GS-15007

(Replaces GS-15006)

General Supplemental Specifications for Highway and Bridge Construction

Effective Date
October 16, 2018

Figure 4137.01-01: AASHTO T 350 Test Temperature by County (°C)

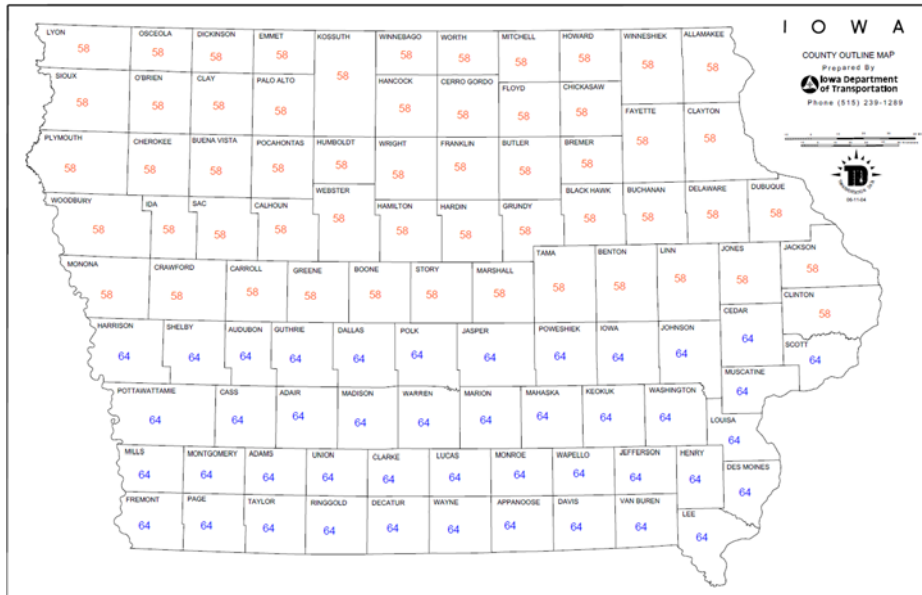
(Delete figure)
